Intersection Road Safety Audit

Maple Avenue & Main Street

Evesham Township,
Burlington County

April 2008

Collision Diagram
Crash Data Years 2004-2006

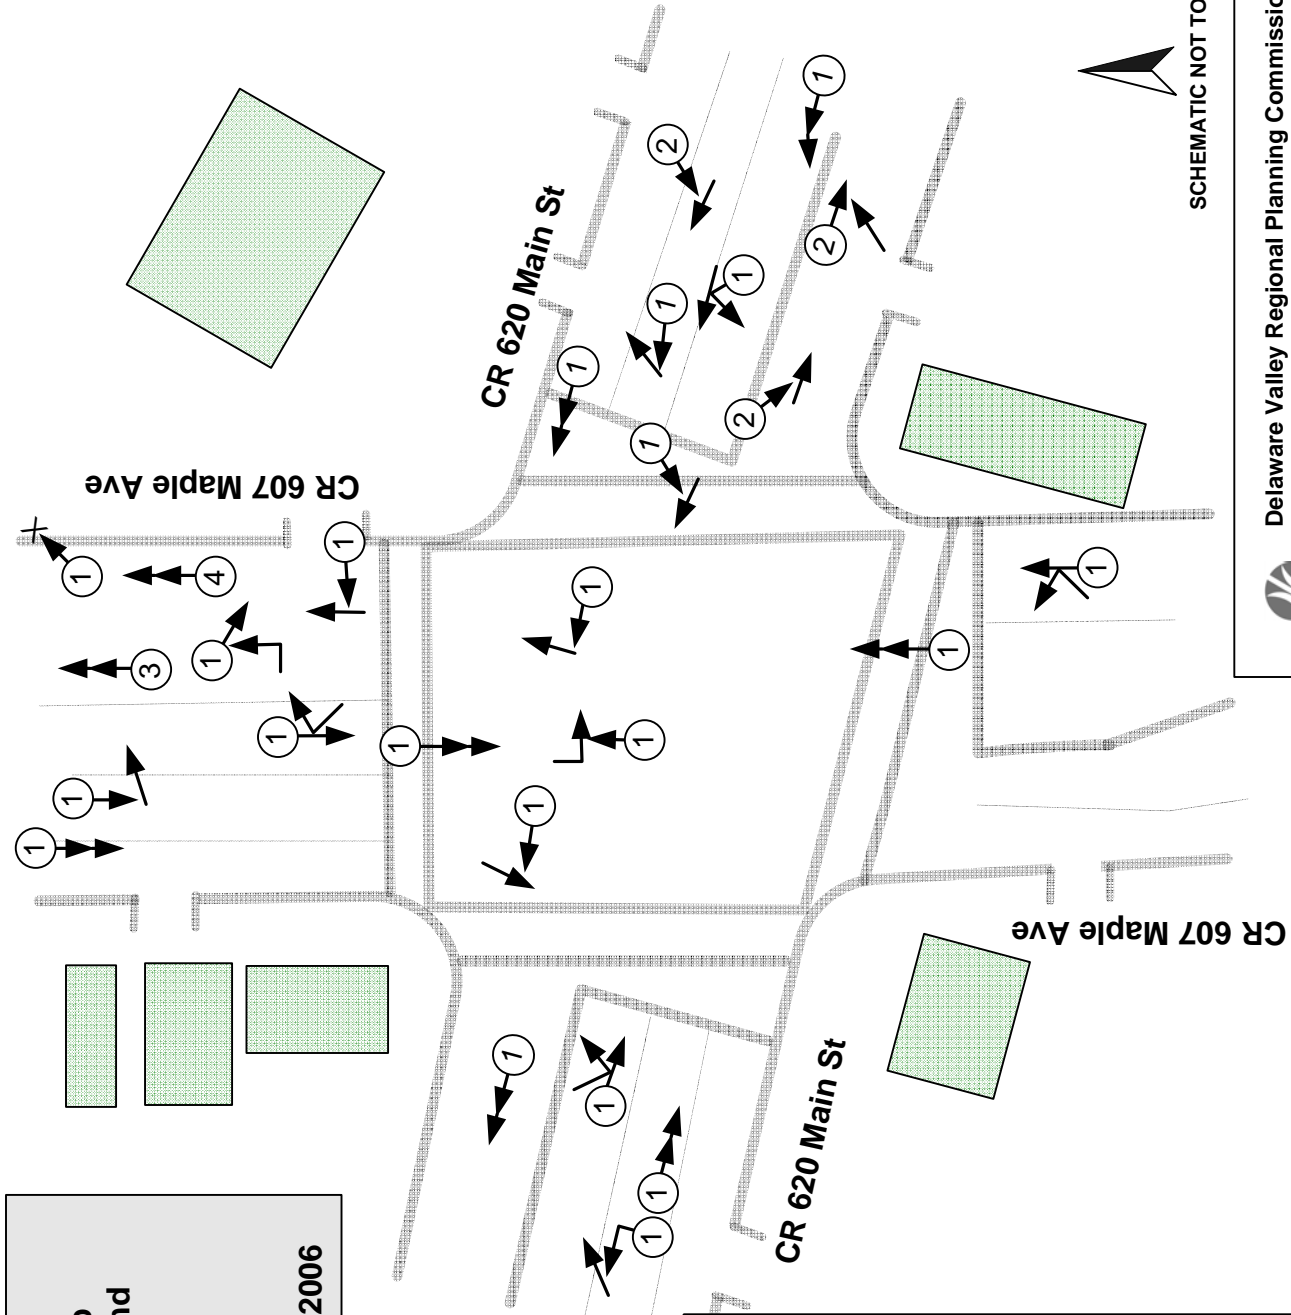
- Driveways are too close to the intersection. Left-turns from these driveways are potentially unsafe considering they are crossing multiple lanes of traffic. From the collision diagram there are a number of crashes associated with the 7-11 convenience store driveways.

- Prohibit left-turns from the 7-11 driveways on Maple Avenue and Main Street.
NJDOT approval of a local ordinance and county resolution will be required prior to the implementation of the prohibitions.
- In the longer term, modify the driveway for right-turns only.
